Braidwood Station, Units 1 and 2
Facility Operating License Nos. NPF-72 and NPF-77
NRC Docket Nos. STN 50-456 and STN 50-457

Byron Station, Units 1 and 2
Facility Operating License Nos. NPF-37 and NPF-66
NRC Docket Nos. STN 50-454 and STN 50-455

Subject: Response to Request for Additional Information Related to Generic Letter 96-06, "Assurance of Equipment Reliability and Containment Integrity During Design-Basis Accident Conditions"

Response to Request for Additional Information (RAI)

Figure 1 Diagram of Hydraulic Model

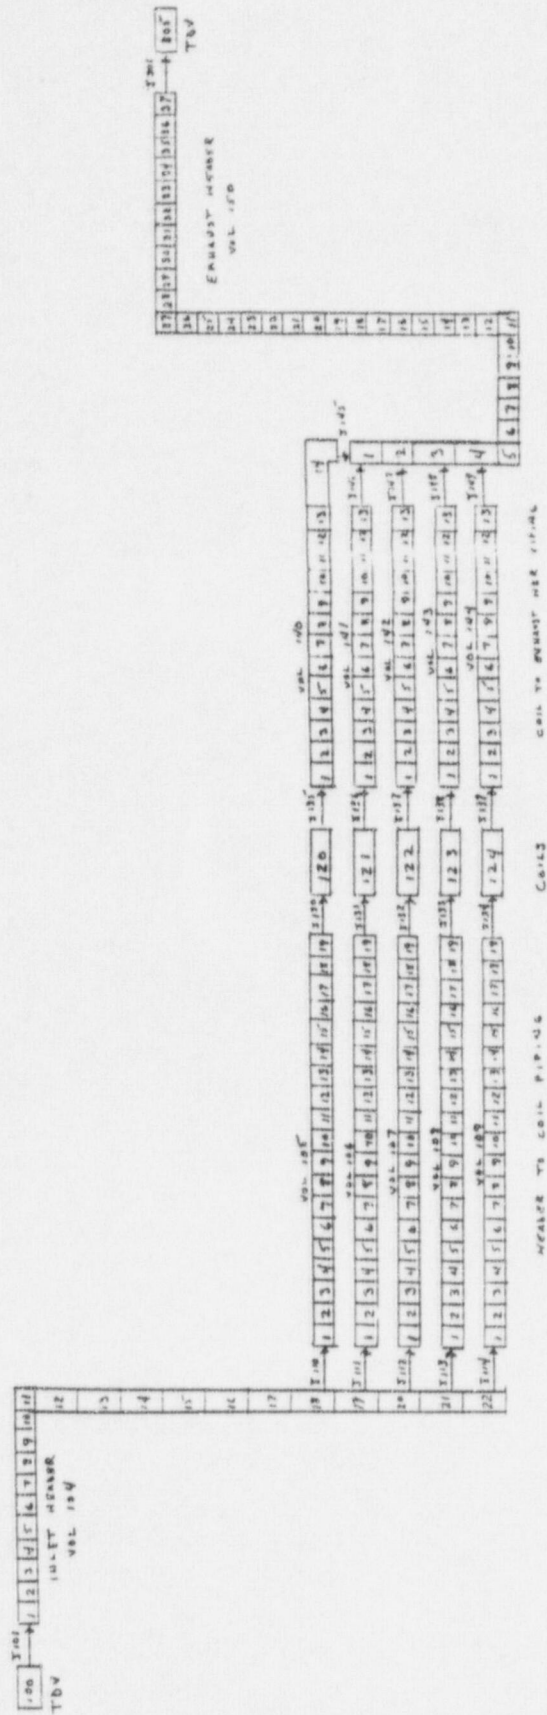
- b) Describe and justify all assumptions and input parameters (including those used in any computer codes) such as amplifications due to fluid structure interaction, cushioning, speed of sound, force reductions, and mesh sizes, and explain why the values selected give conservative results. Also, provide justification for omitting any effects that may be relevant to the analysis (e.g., fluid structure interaction, flow induced vibration, erosion). Information that is contained in the May 2, 1997, submittal that requires no further explanation need not be repeated.

Response: Attachment B of this submittal contains two figures showing the nodalization utilized in the RELAP5/MOD3.1.1 model for the piping and RCFC coils, respectively. In addition, Appendices C and D of the ComEd calculation are provided in entirety in Attachments C and D of this submittal. Appendix C is an input listing of the RELAP5/MOD3.1.1 model. Appendix D provides a description of modeling choices and methods philosophy utilized for each element of the model as well as calculation worksheets used to develop key model inputs.

- Highly detailed nodalization of ½ of a RCFC cooling coil arrangement and the inlet/outlet piping, including modeling of 5 coils in parallel (over 200 piping nodes plus 24 nodes per coil).
- Flow boundary conditions and modeling assumptions that yield early void initiation, and maximize the extent of voiding predicted.
- Heat transfer modeling which includes the effects of the finned surfaces.
- Use of the Uchida condensing correlation, and a heat transfer coefficient actually used that is more than double the predicted values.

Figure 11 LOCA/LOOP TDV Boundary Condition Pressures

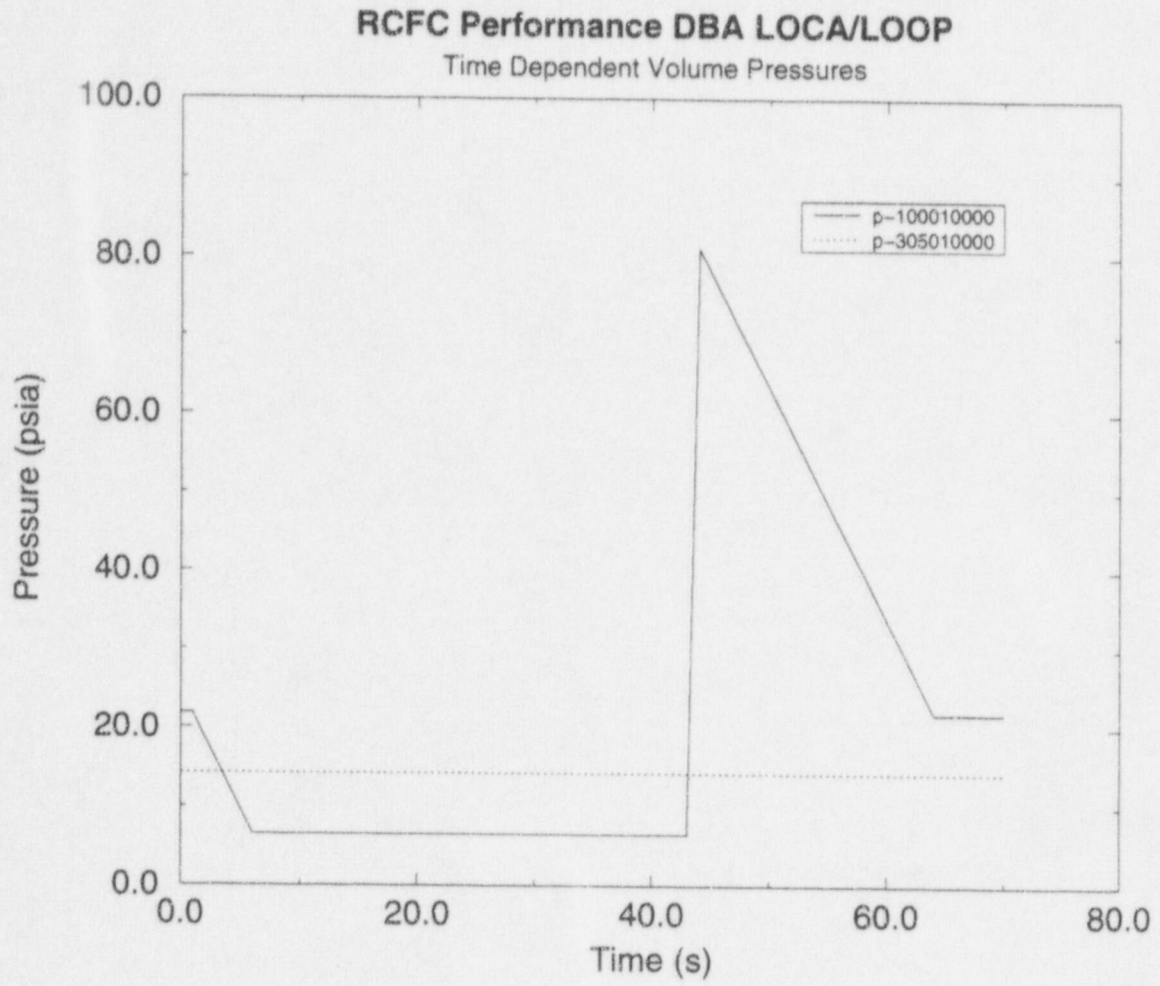
- c) Provide a detailed description of the "worst-case" scenarios for waterhammer and two-phase flow, taking into consideration the complete range of event possibilities, system configurations, and parameters. For example, all waterhammer types and water slug scenarios should be considered, as well as temperature, pressure, flow rates, load combinations, and potential component failures. Additional examples include:
- the effects of void fraction on flow balance and heat transfer
 - the consequences of steam formation, transport, and accumulation
 - cavitation, resonance, and fatigue effects; and
 - erosion considerations.

Figure 11 shows the boundary condition pressures imposed at the time dependent volumes defining the model interfaces with the remainder of the system. As noted previously, a five second coastdown in pressure representing the loss of the SX pump starting at 1 second occurs followed by a rapid spike in pressure at 43 seconds simulating the pump restart with a 20 second decay to the steady state pressure. This profile was chosen to yield a "surge" capable of yielding two phase interactions that would bound the actual plant response. Figure 12 shows the flows at the time dependent volume pressure boundaries resulting from the forcing function defined in Figure 11. As can be seen, the flow decays rapidly following pump trip, and void generation in the coils initiates just prior to 15 seconds. As the void generation continues, fluid is pushed out both sides of the model, until the pump restart occurs. Once boiling in the coils stops, the conditions favor discharge side reflooding. Figures 13 through 17 provide the flows at the entrance and exit junctions of each coil subassembly. These plots clearly demonstrate the flow reversal occurring during void generation, as well as the discharge side reflood prior to pump startup.

BRAIDWOOD PIPING AND EQUIPMENT ELEVATIONS

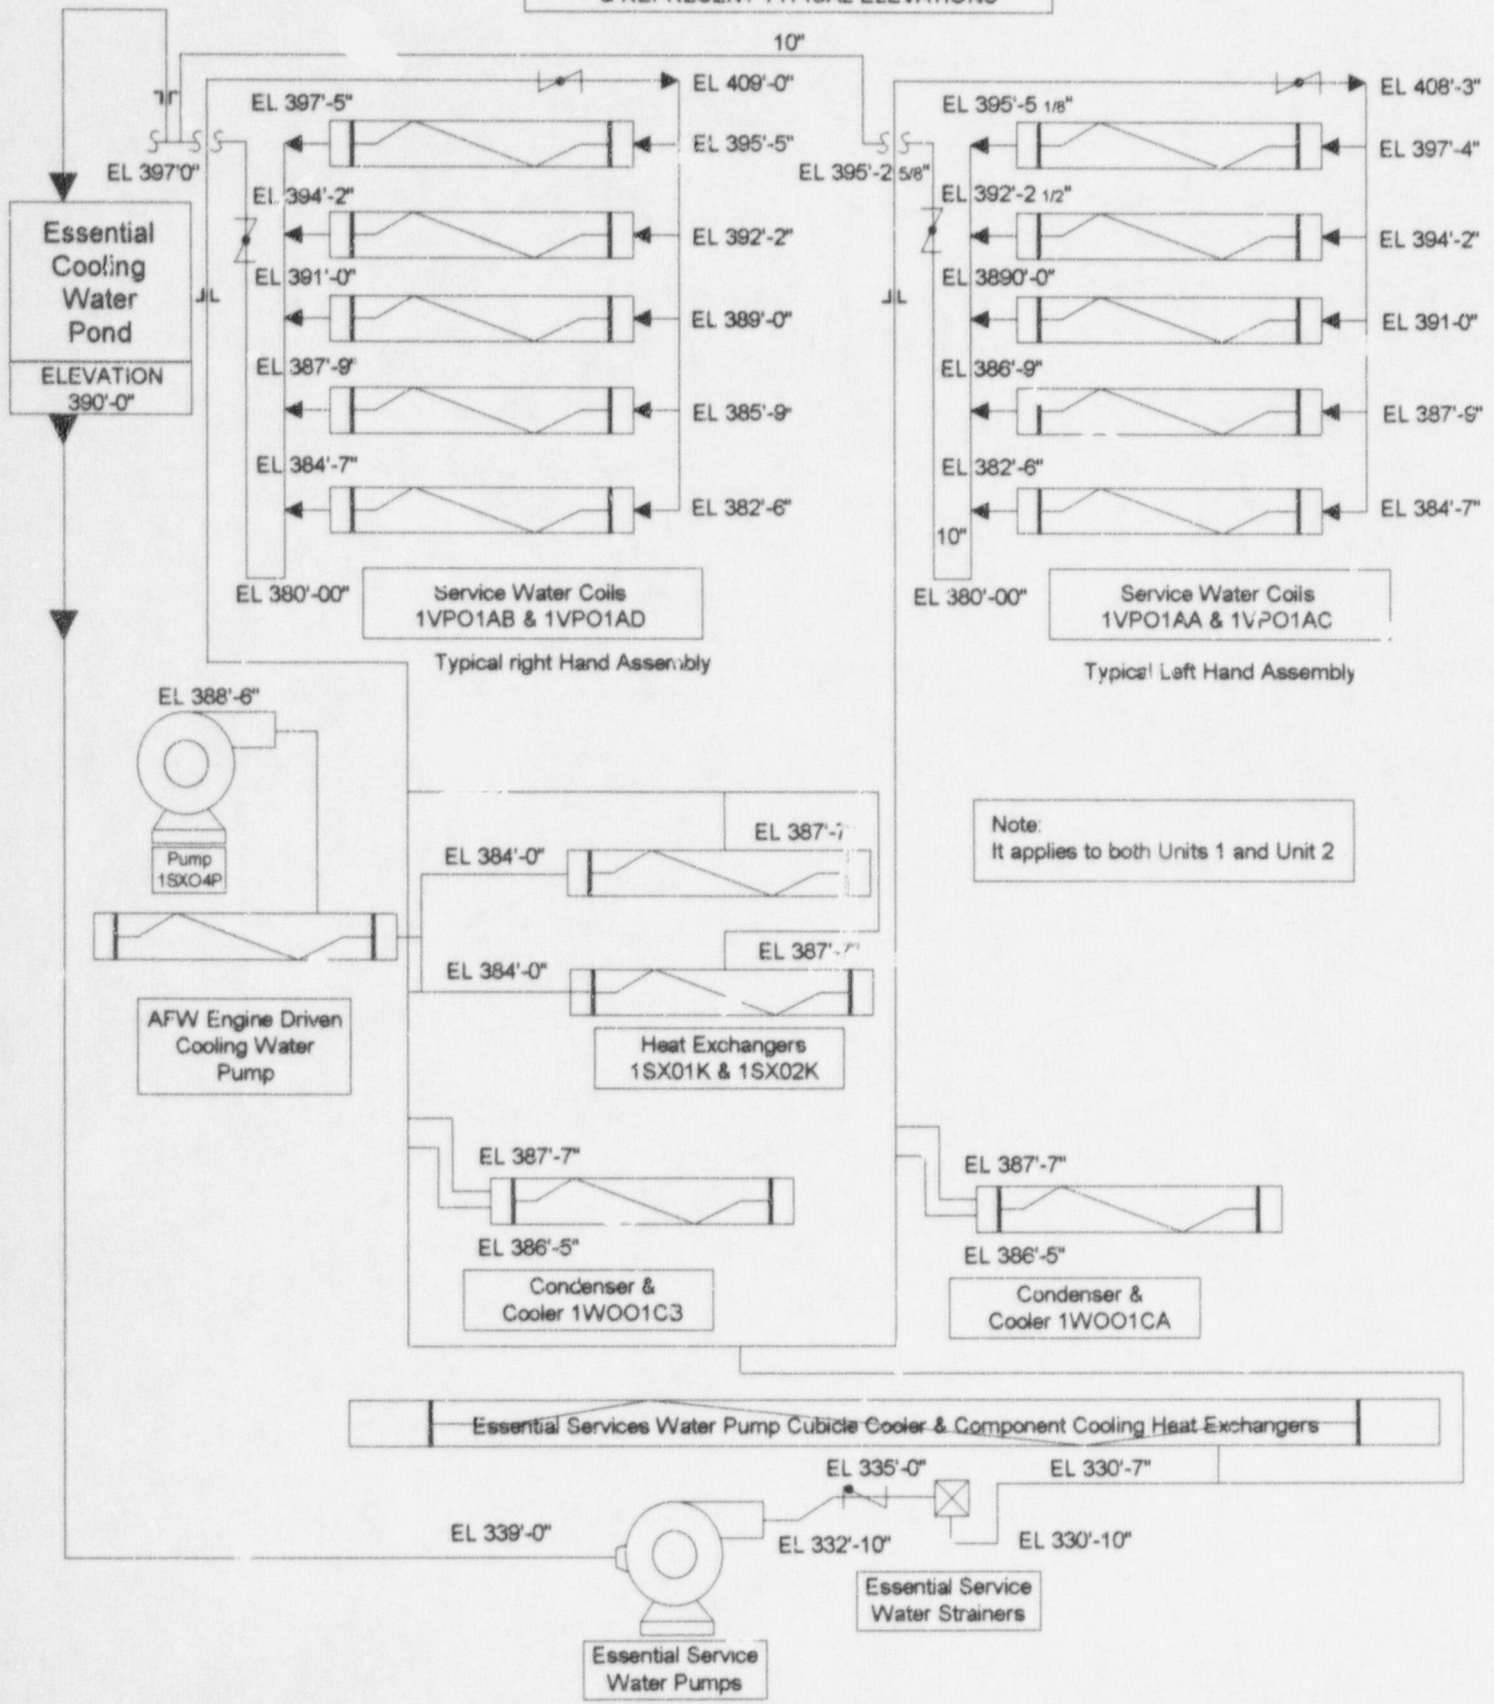
5. **Provide a simplified diagram of the system, showing major components, active components, relative elevations, lengths of piping runs, and the location of any orifices and flow restrictions.**

Response: Piping and equipment elevations are provided in Attachment F of this submittal.
